## STAFF REPORT

<b>Company: BHP Billiton Diamonds Inc.</b>	
<b>Location: Ekati Mine Site</b>	<b>Application No.: MV2001F0032</b>
<b>Date Prepared: January 30, 2003</b>	<b>Meeting Date: February 13, 2003</b>
<b>Subject: Technical Specification and Construction Drawings: Stream Crossings for the Sable Road</b>

GENERAL LOCATION PLAN

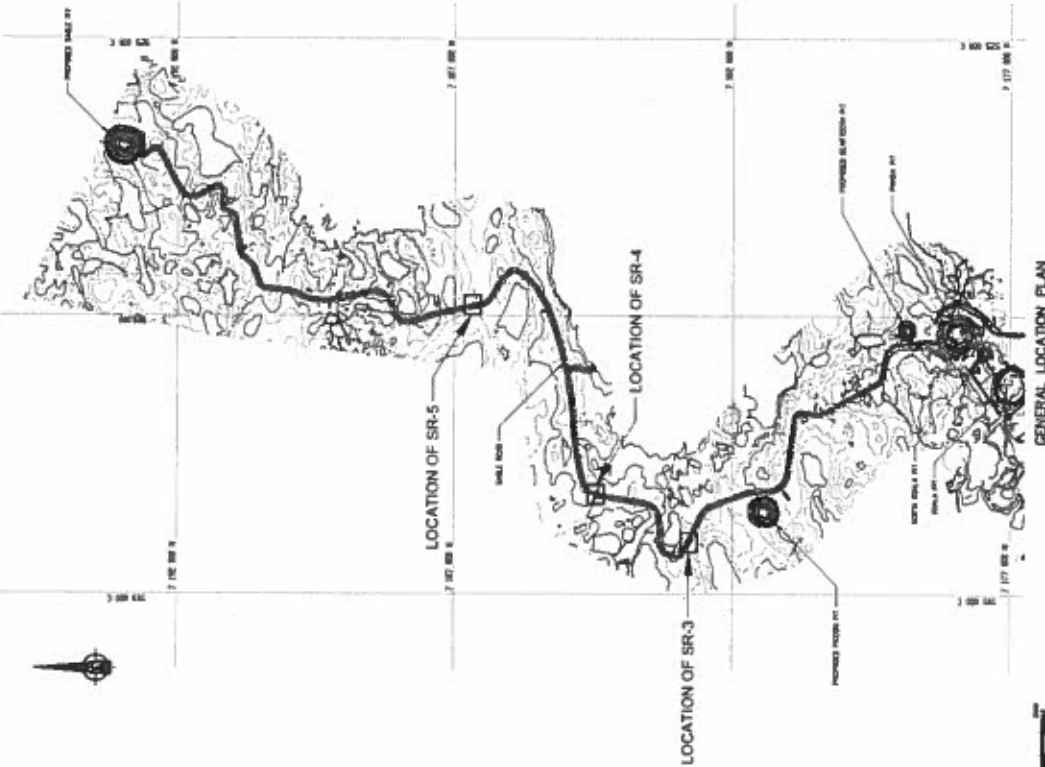
Organization & Contact	Concerns/ Suggestions	How they were dealt with / incorporated
AMEC Earth and Environmental- Neil van der Gugten	<ul style="list-style-type: none"> <li>• The subject streams have not been adequately characterize.</li> <li>• The appropriateness and adequacy of the proposed culvert designs for the subject streams have not been demonstrated.</li> <li>• The provision of fish passage through the proposed culverts has not been adequately addressed.</li> <li>• The installation designs for the culverts do not show an adequate bottom (invert) depth below the streambed.</li> </ul>	The department of Fisheries and Oceans has to approve the construction plans as well, therefore they will be able to address these concerns in their approval decision.

<p>DIAND – Darnell McCurdy</p>	<ol style="list-style-type: none"> <li>1. Has a watershed/drainage analysis been completed? If not how was the culvert size of 1000mm chosen and why are 2 culverts to be installed in locations SR3 and SR5?</li> <li>2. What was the flood cycle that was used in determination of the culvert size? 1:50, 1:100, 1:200.</li> <li>3. In the Section titled "General" 2.1 it is indicated that there will be borrow and stockpile areas utilized. If this is the case where will these areas be located?</li> <li>4. I am assuming that the source of the 20mm and 150mm crush will be from the granite waste rock generated from the open pits. Is this correct or will a quarry be needed?</li> <li>5. There was no mention of the use of silt curtains for the upcoming freshet. There is potential for silt and fines to move after construction during increased water flows.</li> <li>6. Are there going to be any stationary fueling facilities at any of these sites during construction? If so I will certainly be looking for lined and bermed structures to accommodate the fueling facilities.</li> <li>7. Where will the debris and vegetative strippings from these culverts installations be placed?</li> </ol>	<p>All questions were answered in the Letter from BHP to MVLWB, Jan 8, 2003.</p> <ol style="list-style-type: none"> <li>1. Culverts will be a minimum size of 900 mm to reduce the potential blockage by ice and debris, and to maintain flows under 1.0 m/s, thereby allowing fish passage. Two culvers are required to keep the flow below 1m/s even in a 1:200 AEP flood flow.</li> <li>2. 1:100</li> <li>3. Within the foot print of the road and will not be placed on the tundra.</li> <li>4. The crush material will be granite crush from either Koala or Beartooth pits.</li> <li>5. Silt curtains are available to place in steams if necessary.</li> <li>6. A fuel truck will deliver fuel on a regular basis.</li> <li>7. All material excavated will be returned to the main site where it will be placed in the salvage topsoil stockpiles.</li> </ol>
